AIRPORT LAND USE COMMISSION RIVERSIDE COUNTY

RE: AIRPORT LAND USE COMMISSION (ALUC) DEVELOPMENT REVIEW

File No.: ZAP1075PS19

Related File Nos.: CUP No. 01-18 (Conditional Use Permit); VAR No. 01-18 (Variance)

| Structure: | Wind Turbine T1 |

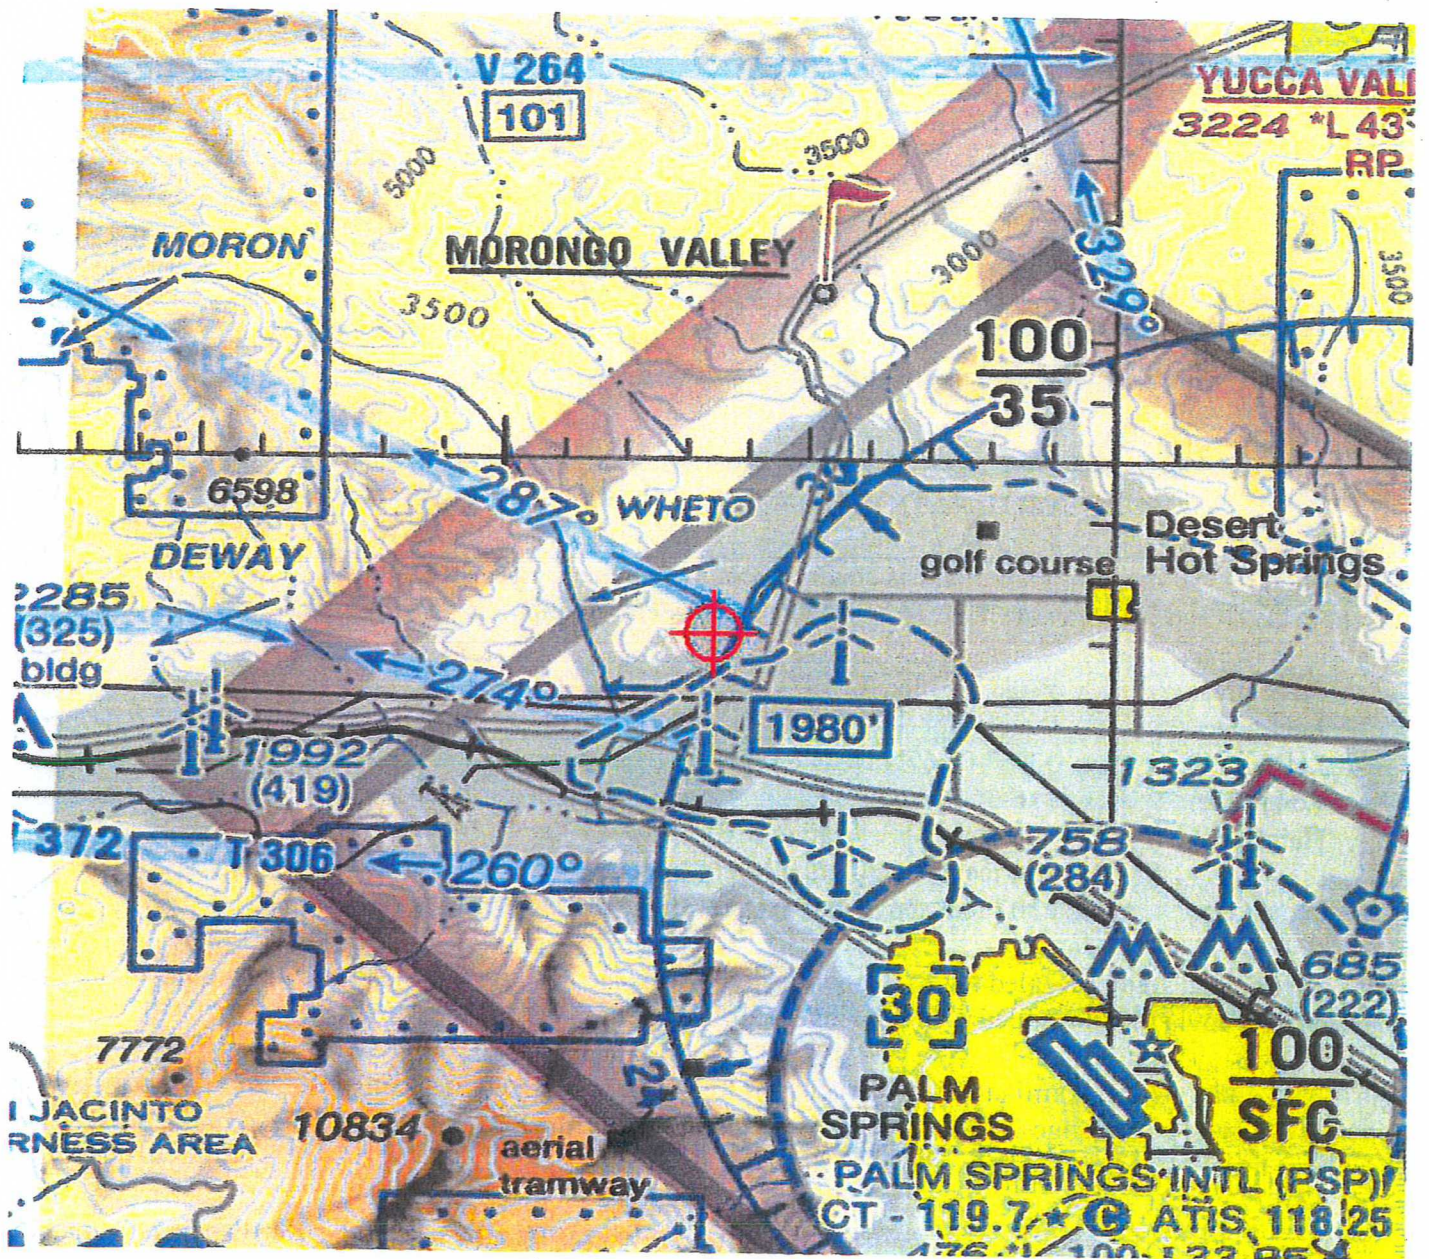
As a condition to this Determination, the structure is to be marked/lighted in accordance with FAA Advisory circular 70/7460-1 L Change 2, Obstruction Marking and Lighting, white paint/synchronized red lights - Chapters 4, 12 & 13 (Turbines).

Aeronautical study indicates that the turbines will be within the radar line of sight for the Palm Springs (PSP) Airport Surveillance Radar (ASR-9) facility. They could cause unwanted primary targets (clutter) and primary-only target drops in the immediate vicinity of the wind turbines. Also, tracked primary-only targets could diverge from the aircraft path and follow wind turbines, when the aircraft is over or near the turbines. However, this would not cause an unacceptable adverse impact on Air Traffic Control operations at this time.

| Structure: | Wind Turbine T2 |

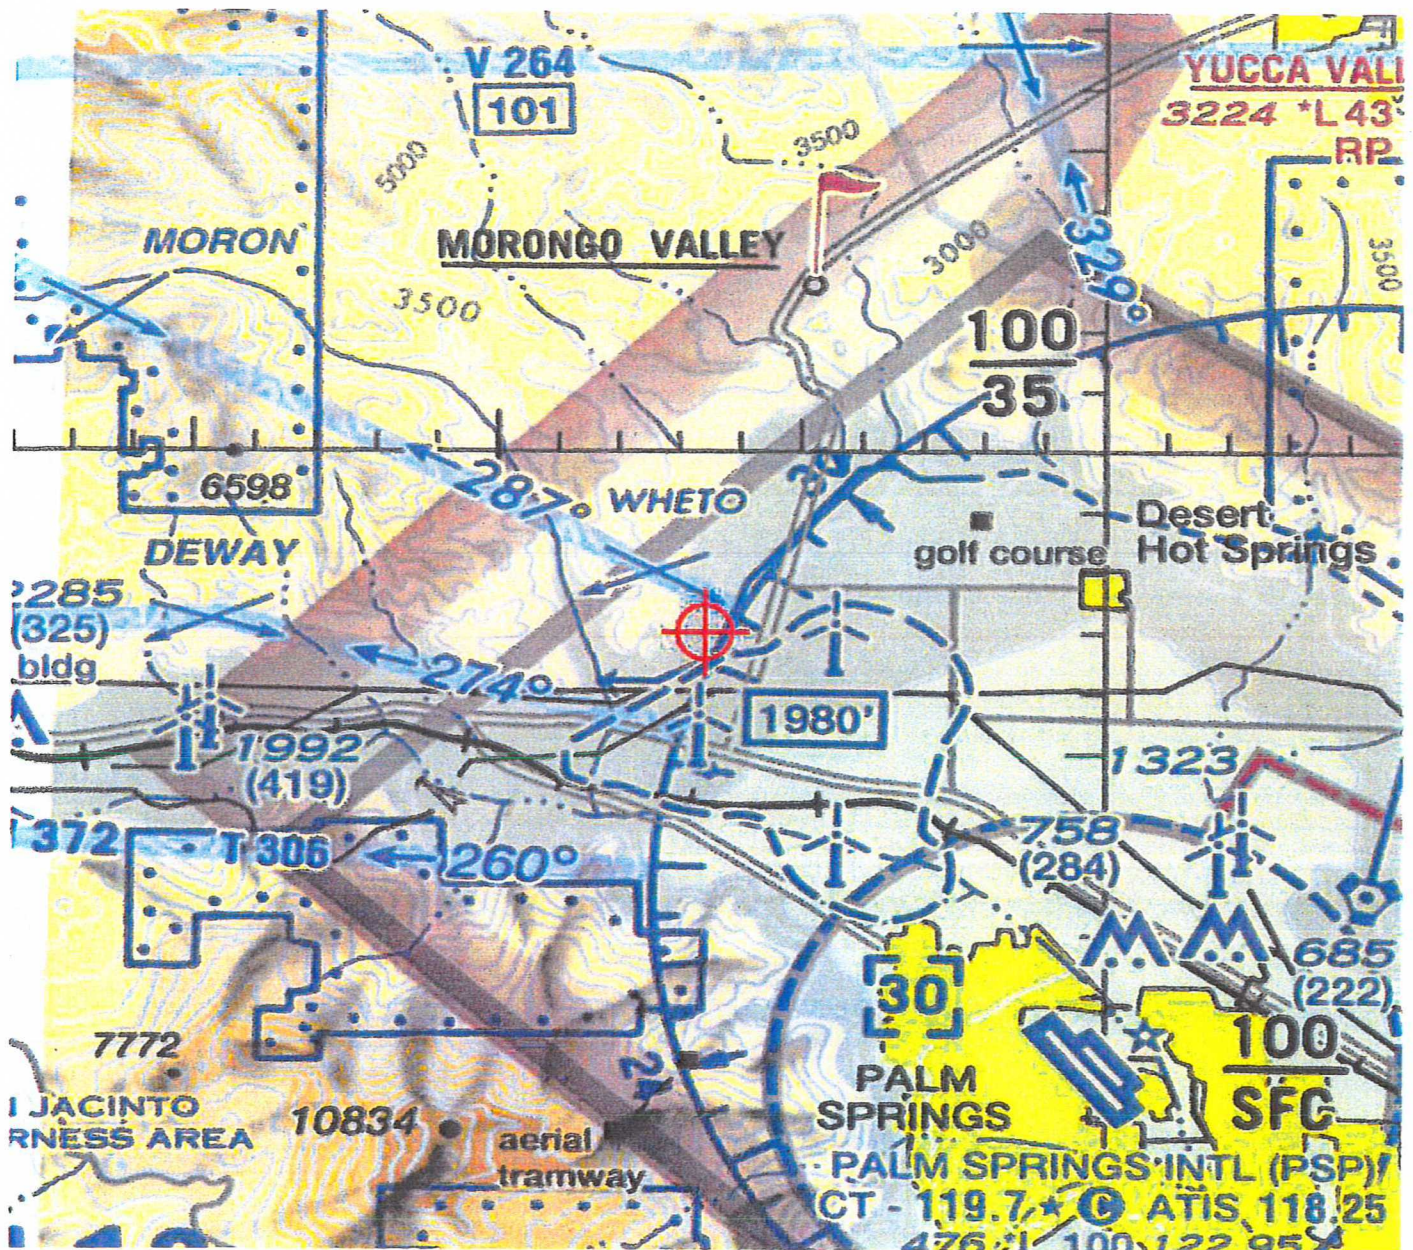
As a condition to this Determination, the structure is to be marked/lighted in accordance with FAA Advisory circular 70/7460-1 L Change 2, Obstruction Marking and Lighting, white paint/synchronized red lights - Chapters 4,12&13(Turbines).

Aeronautical study indicates that the turbines will be within the radar line of sight for the Palm Springs (PSP) Airport Surveillance Radar (ASR-9) facility. They could cause unwanted primary targets (clutter) and primary-only target drops in the immediate vicinity of the wind turbines. Also, tracked primary-only targets could diverge from the aircraft path and follow wind turbines, when the aircraft is over or near the turbines. However, this would not cause an unacceptable adverse impact on Air Traffic Control operations at this time.

| Structure: | Wind Turbine T3 |

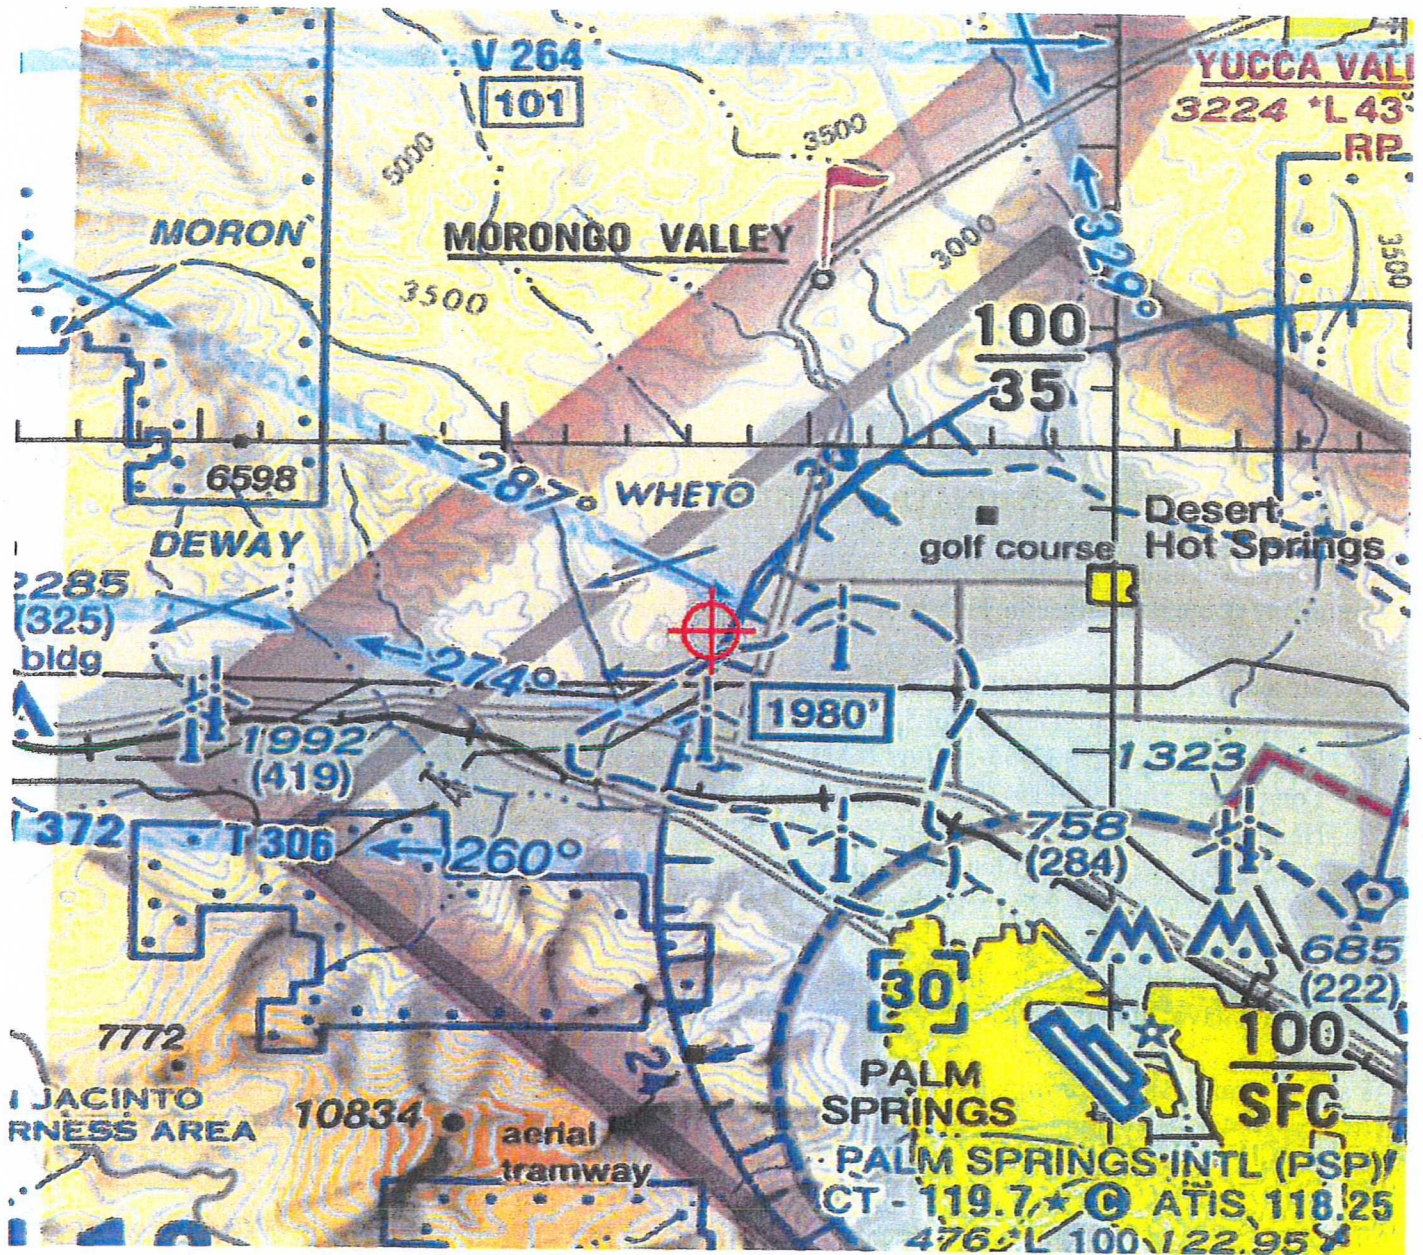
As a condition to this Determination, the structure is to be marked/lighted in accordance with FAA Advisory circular 70/7460-1 L Change 2, Obstruction Marking and Lighting, white paint/synchronized red lights - Chapters 4, 12 & 13 (Turbines).

Aeronautical study indicates that the turbines will be within the radar line of sight for the Palm Springs (PSP) Airport Surveillance Radar (ASR-9) facility. They could cause unwanted primary targets (clutter) and primary-only target drops in the immediate vicinity of the wind turbines. Also, tracked primary-only targets could diverge from the aircraft path and follow wind turbines, when the aircraft is over or near the turbines. However, this would not cause an unacceptable adverse impact on Air Traffic Control operations at this time.

| Structure: | Wind Turbine T4 |

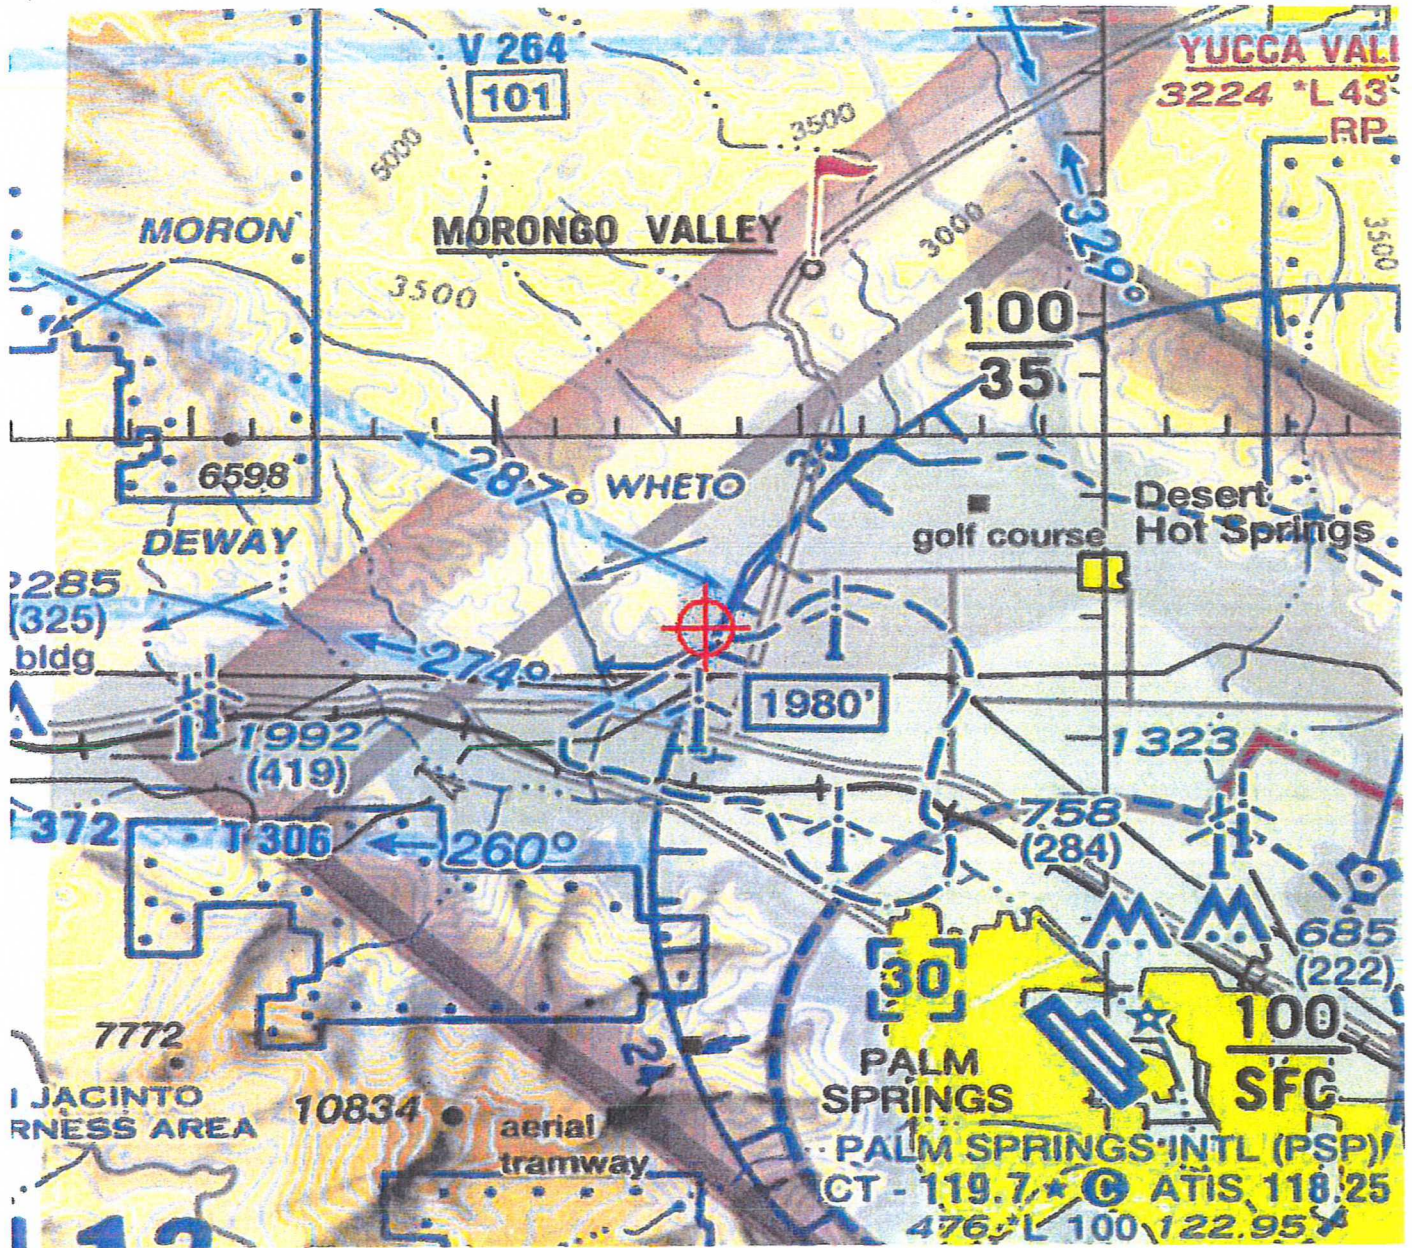
As a condition to this Determination, the structure is to be marked/lighted in accordance with FAA Advisory circular 70/7460-1 L Change 2, Obstruction Marking and Lighting, white paint/synchronized red lights - Chapters 4,12&13(Turbines).

Aeronautical study indicates that the turbines will be within the radar line of sight for the Palm Springs (PSP) Airport Surveillance Radar (ASR-9) facility. They could cause unwanted primary targets (clutter) and primary-only target drops in the immediate vicinity of the wind turbines. Also, tracked primary-only targets could diverge from the aircraft path and follow wind turbines, when the aircraft is over or near the turbines. However, this would not cause an unacceptable adverse impact on Air Traffic Control operations at this time.
